November 24, 2014

San Luis Obispo County  
Department of Planning and Building  
Murry Wilson  
976 Osos Street  
San Luis Obispo, CA 93408

**RE: Comments on the Revised Draft Environmental Impact Report for the Phillips 66 Company Rail Spur Extension and Crude Unloading Project**

Phillips 66 map indicating plans to transport Western Canadian crude oil to San Francisco Refinery.<sup>17</sup> Notice that the icon labeled “San Francisco” identifies the San Francisco Refinery, which includes the Santa Maria facility.

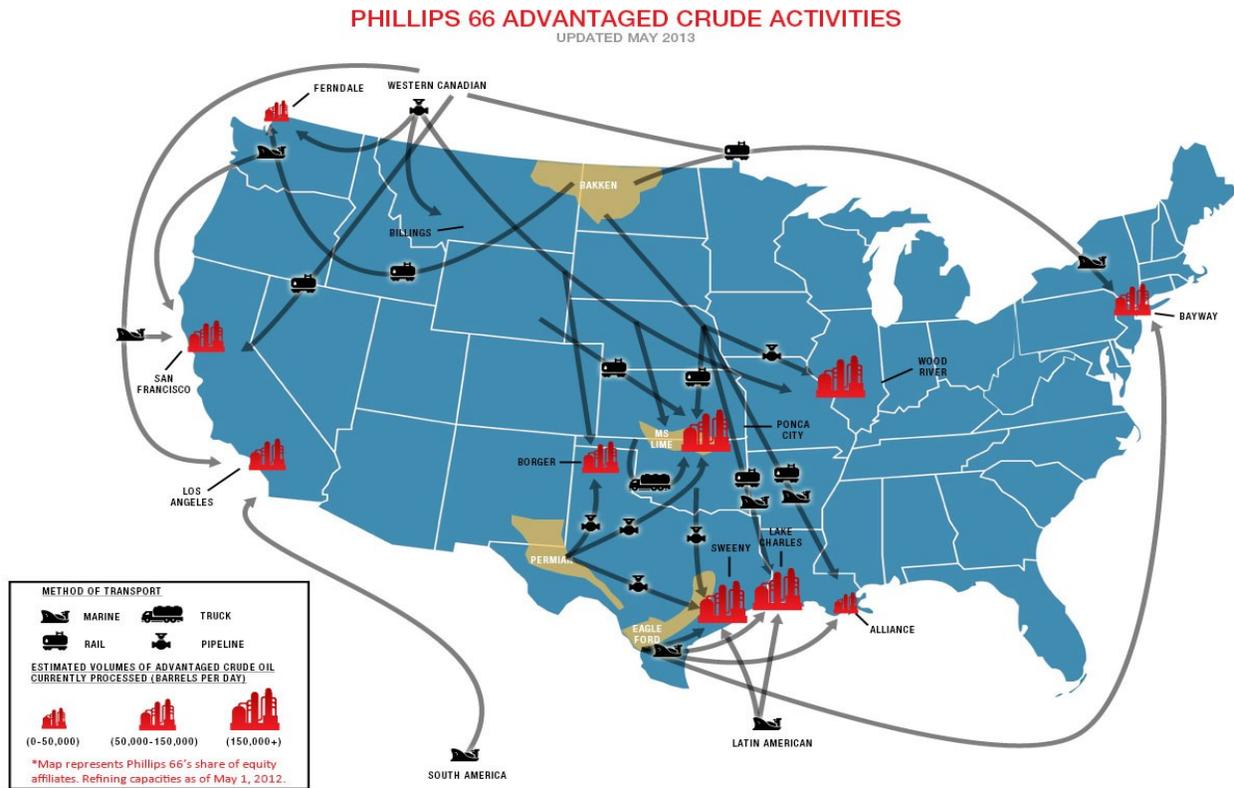
Furthermore, "[a]n accurate project description is necessary for an intelligent evaluation of the potential environmental effects of a proposed activity."<sup>12</sup> Thus, an inaccurate or incomplete project description renders the analysis of significant environmental impacts inherently unreliable. While extensive detail is not necessary, the law mandates that EIRs should describe proposed projects with sufficient detail and accuracy to permit informed decision-making.<sup>13</sup> The RDEIR's Project Description fails to meet this standard by minimizing the degree and scope of the switch in crude oil feedstock supply.

CBE-06

CBE-54

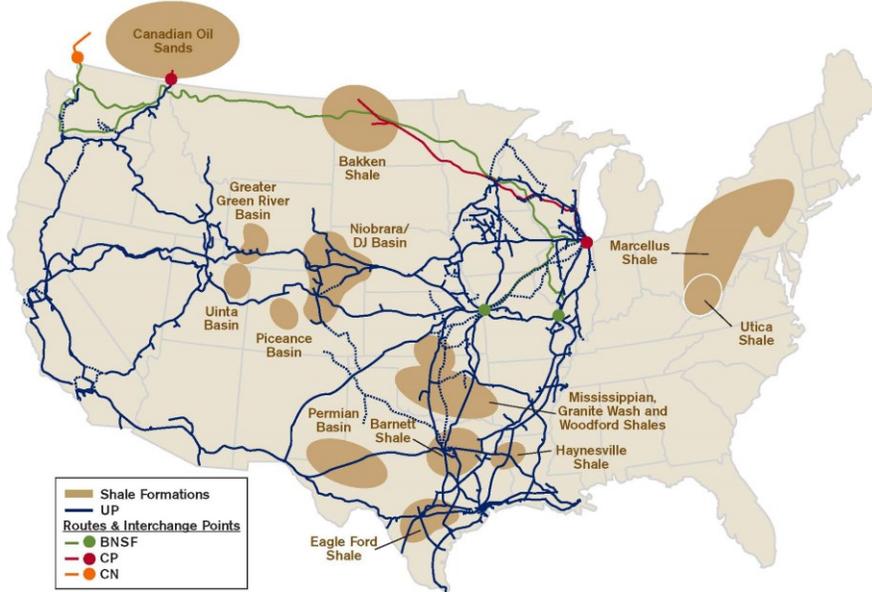
The RDEIR limits its analysis of the impacts from a crude oil spill along the UPRR mainline to the section of track between the Roseville and Colton rail yards. However, CEQA requires an EIR to discuss the significant impacts that the proposed project will have in the relevant geographic area.<sup>233</sup> Agencies must “provide a reasonable explanation for the geographic limitation used,”<sup>234</sup> and the geographic scope “cannot be so narrowly defined that it necessarily eliminates a portion of the affected environmental setting.”<sup>235</sup>
